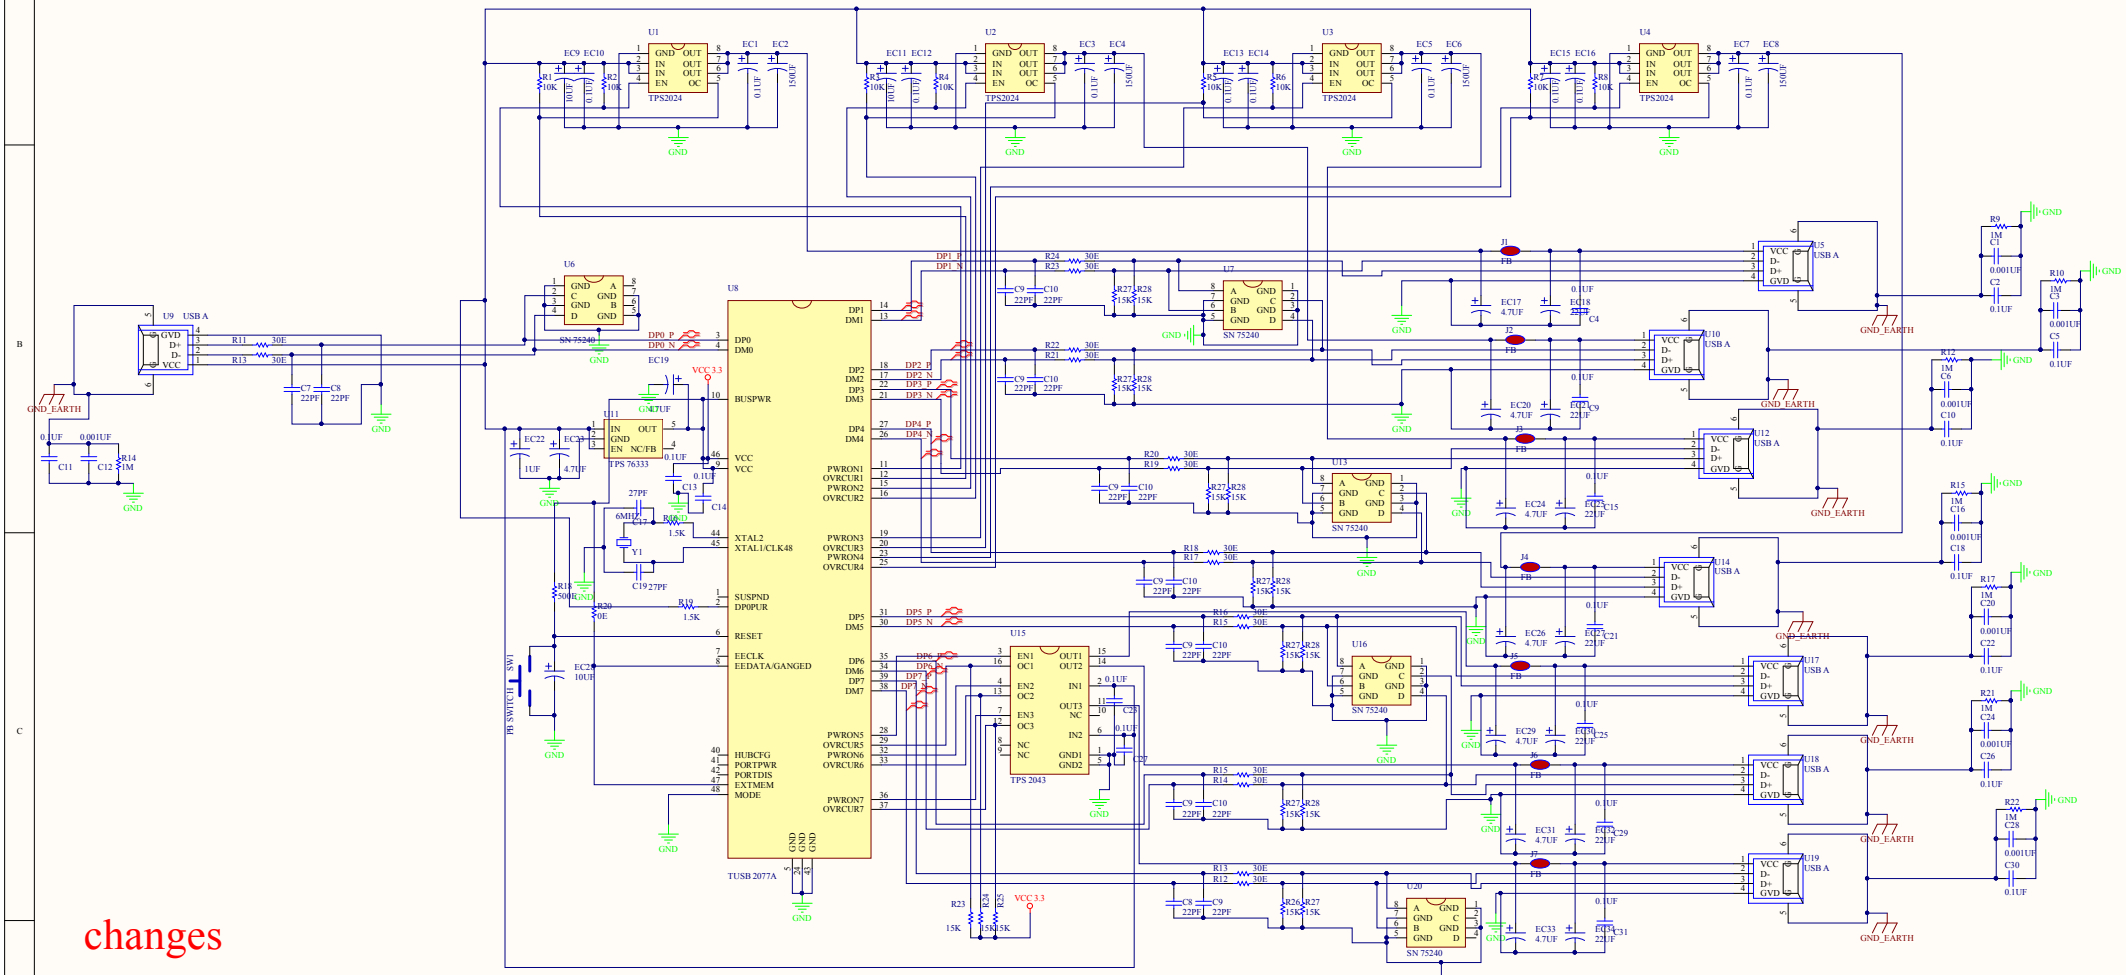
10K PULL UP is given to the OC pin in TPS2024 IC(asper ic datasheet)

1. resistors added at DATA pins of input USB side
2. capacitors added after resistors at input USB side
3. ferrite beed circuit added to the power supply pin of the output USB connectors
4. earth point added to all USB connectors
5. earth to ground circuit added to all USB connectors AS PER THE 2077A EVM REFERENCE CIRCUIT
6. 15k pullup resistors added from 3.3v to OC pins of the TPS2043
7. 22pf, 30e resistor, 15k resistor added to every data+ and data- pin of the output ports

{since additional circuitry added, designators are changed}
